SERVICE BULLETIN

APPLICABILITY: 2019-23MY Forester

SUBJECT:	Genuine Alternative Battery Replacement
----------	---

NUMBER:
 07-218-23R

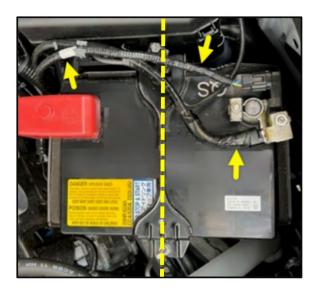
STEP 4: Install the NEW battery cover (**p.n. 82123AN000**) to the alternative replacement battery. Confirm the bottom of the cover is aligned flush with the bottom of the battery.
